Re: SCH File # 17-E-4600-0208; Application of NTE Carolina II, LLC for Certificate to construct a 500 MW Natural Gas Fueled Merchant Power Plant in Rockingham Co. Docket # EMP-92 Sub 0.

To:	Crystal Best State Clearinghouse Coordinator Department of Administration
From:	Lyn Hardison $\mathcal{LBH}$ Division of Environmental Assistance and Customer Service Environmental Assistance and Project Review Coordinator
RE:	17-0208 (17-0119) Environmental Review – Application of NTE Carolina II, LLC for the Certificate to construct a 500 MW Natural Gas Fueled Merchant Power Plant Rockingham County

SUBJECT: Comments on NTE Carolinas II, LLC Amended Natural Gas Power Plant Facility in Rockingham County; Project Number 17-0208.

Superfund Section SEPA Review 17-0119

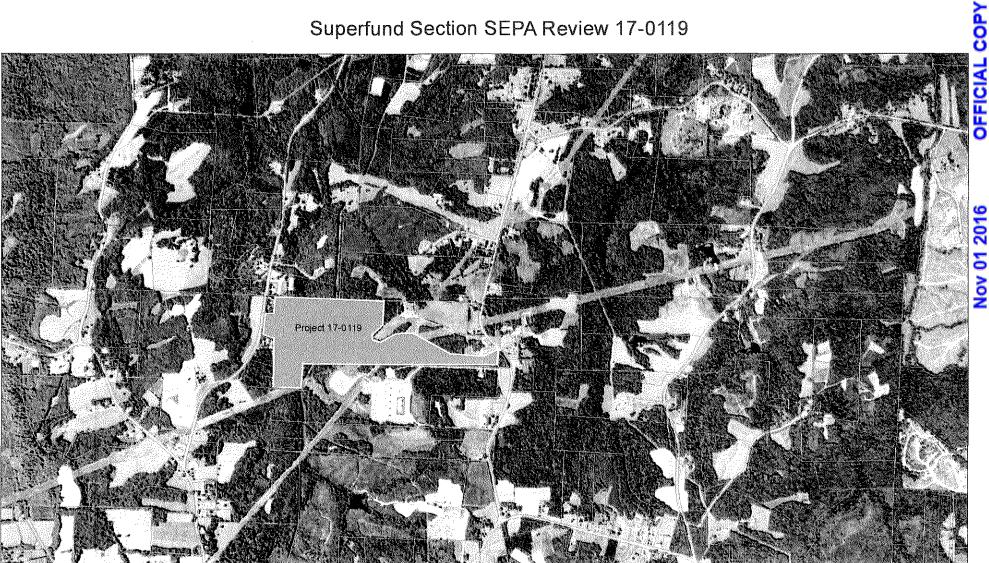
The Superfund Section has reviewed the proximity of CERCLIS and other sites under their jurisdiction to the construction of a 500 MW Natural Gas-Fueled Merchant Power Plant in Rockingham County, NC.

No sites were identified within one mile of the project as shown on the attached map.

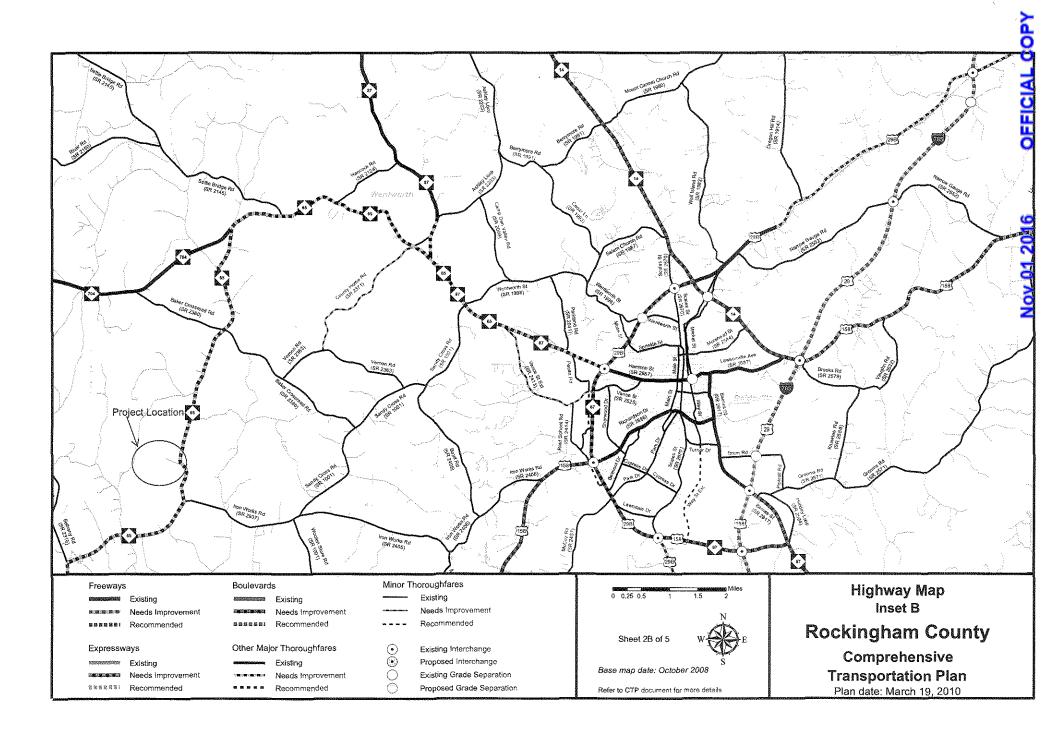
The proposed project is located in Rockingham County. Roadway facilities, which may be impacted by the proposed project and are part of the current Rockingham County **Comprehensive Transportation Plan (CTP):**

NC 65 Major Thoroughfare (Needs Improvement) æ

The proposed access road to the project will tie onto NC 65, just north of Earnest Drive.
